# Staff Report

Knoxville Historic Zoning Commission

File Number: 3-F-26-HZ

**Location:** 1803 Clinch Ave. **Parcel ID:** 94 N K 018  
**District:** Ft. Sanders NC  
**Zoning:** O (Office)  
**Description:** Georgian Revival, c.1912  
Roddy House. Two-story, brick masonry residence with a hipped roof and hipped roof dormers.

# PROPOSED ELEVATIONS

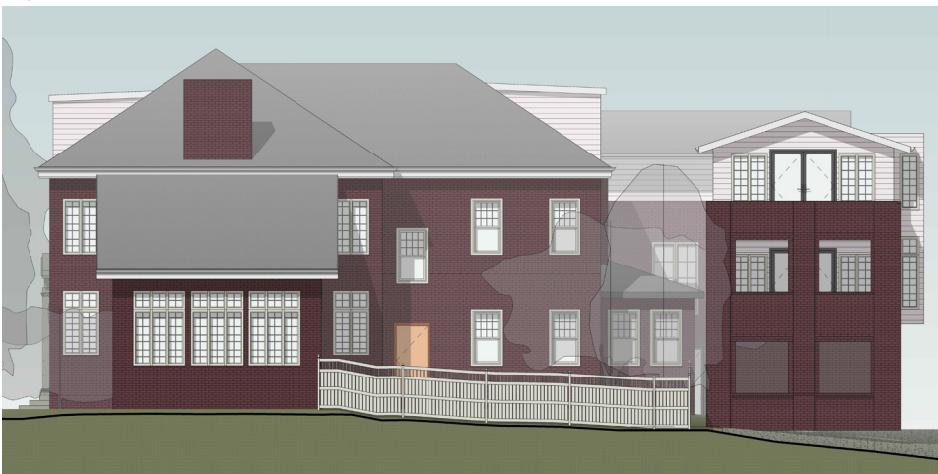
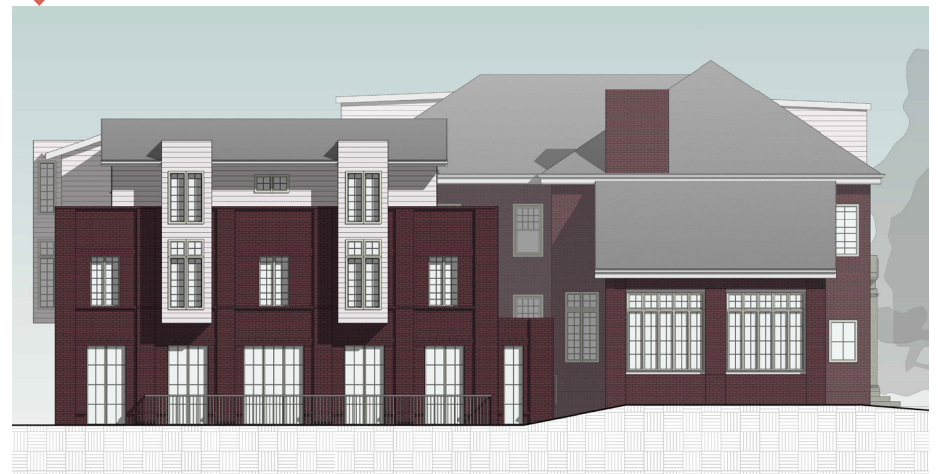
6. Guidelines recommend that roof pitches be compatible with historic houses in the neighborhood, not less than an 8/12 pitch. The 4/12 is not steep enough to reflect the historic house on the property or in the immediate context. The combination of multiple rooflines, including the flat-roofed bay windows, the flat balcony parapets, and the 4/12 pitch cross-gables creates an overly complex effect that is not visually cohesive with the primary structure.

9. Guidelines recommend that window proportions and symmetry be comparable to historic houses in the neighborhood. The guidelines also specify that double-hung windows should be used. While casement or fixed windows may be appropriate if comparable in proportion and design to the original house, the new building (particularly the west and north elevations) features multiple different window sizes and configurations. There are also multiple configurations of “multi-light” windows (which will feature grids-between-the-glass) In the opinion of staff, grids-between-the-glass do not sufficiently reflect the window styles of the primary house and exterior muntins would be preferable. The windows on the north and west elevations should be revised to create more consistent proportions, symmetry, and pane configuration.

The projecting bay window massings are large in scale, not compatible with the original house, and add unnecessary complexity to the rear and left side elevations. The projecting bays should be revised or removed altogether; one approach could be to revise the flat rooflines to function as gable-roof dormers comparable to the primary house.

The roof pitch should be revised to be more compatible with the primary house. One approach may be revising the intersecting 4/12 pitch roofs to a proper cross-gable roofline.

# ELEVATIONS

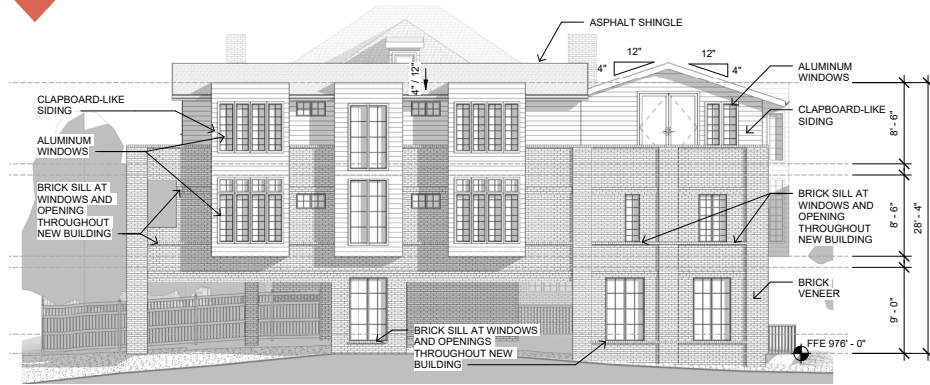
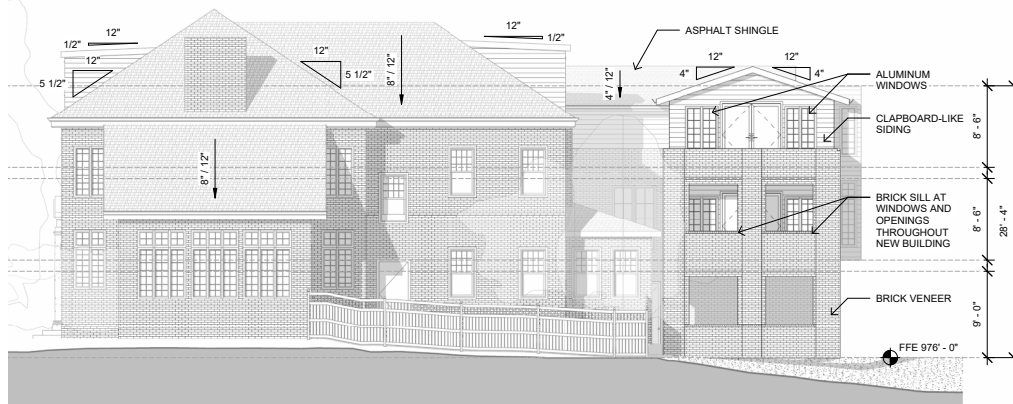
The original house’s casement windows feature defined casing between the individual window units. All grouped windows on the new building should also feature casing in a width consistent with the primary house.
